Certificate of Appropriateness

Property 601 W. HISTORIC MITCHELL ST. Mitchell Street Historic District
Description of work Applicant proposes to remove two Cricket signs installed in 2008 and replace them with new ones at the same locations.
Date issued 3/24/2015 PTS ID 101031 COA

Existing

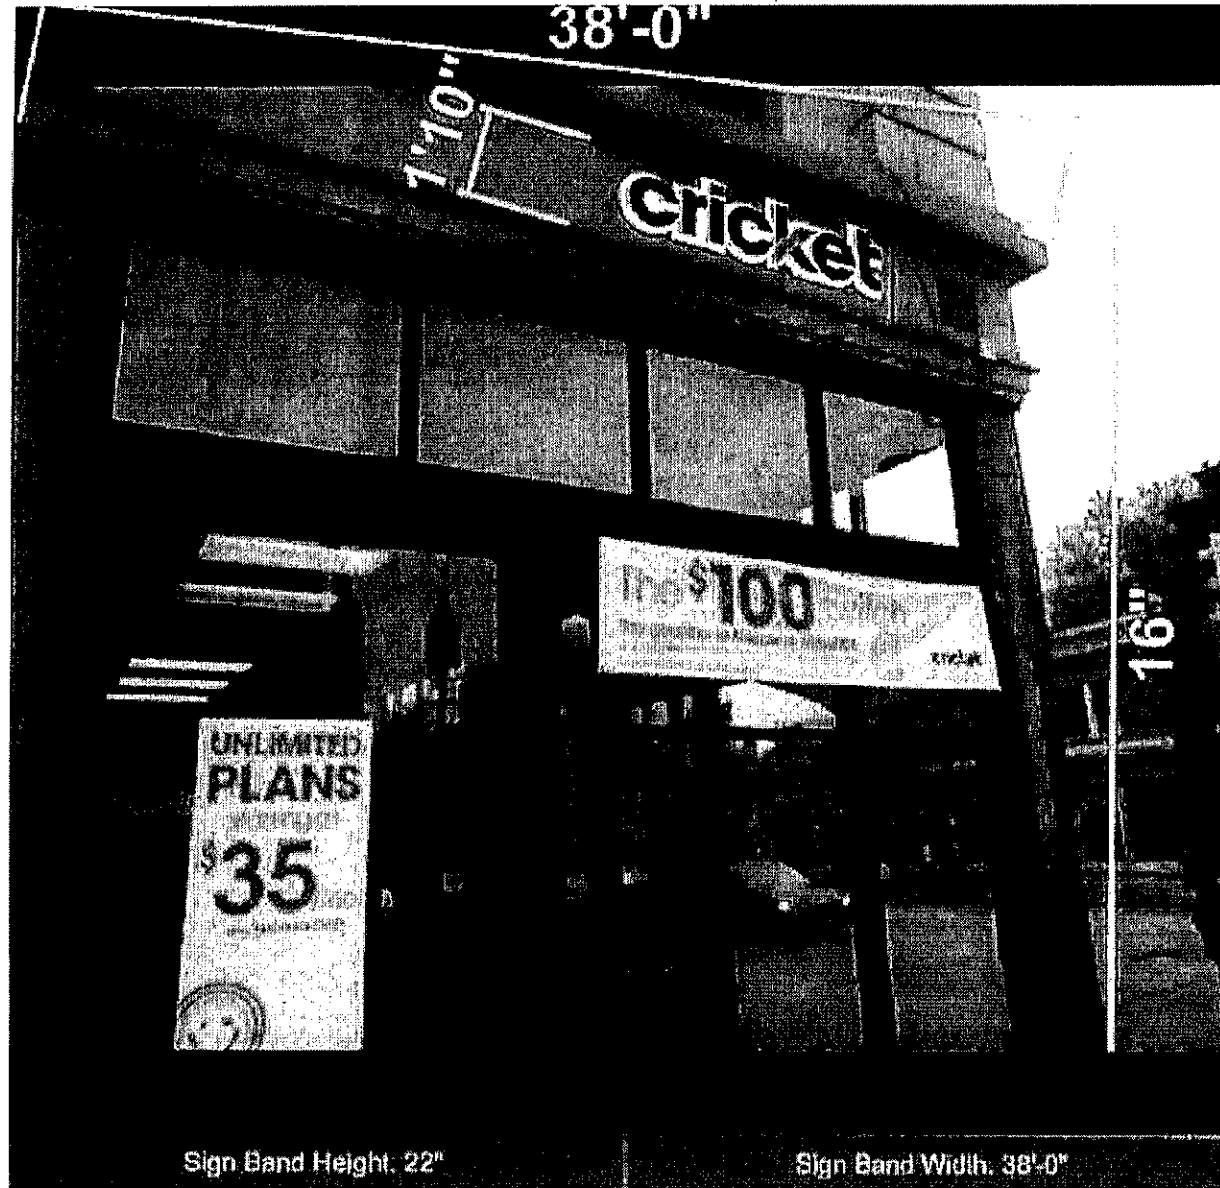
The current Cricket signs are installed at the corner storefront in the sign zone above transom windows. The tallest portion of the signs are 15 inches tall and the width is 4'-8" long. They are individually illuminated letters.

Proposed new signs

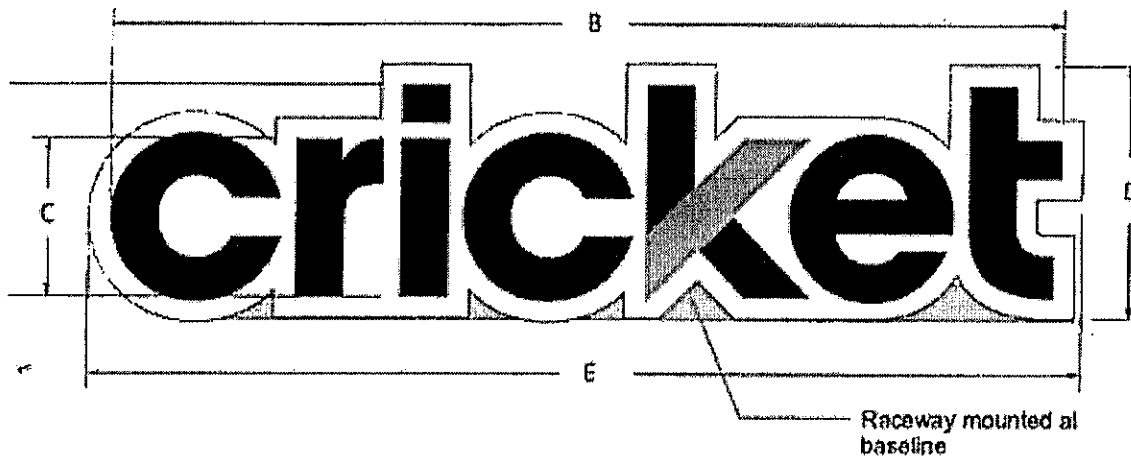
The proposed signs will be taller, at 20 inches and longer at 6'-3 15/16". They will fill most of the sign band area that is 1'-10" or 22 inches in height.

The letters will be mounted to the raceway at the baseline.

No portion of the sign can extend above or below the borders of the sign band zone.
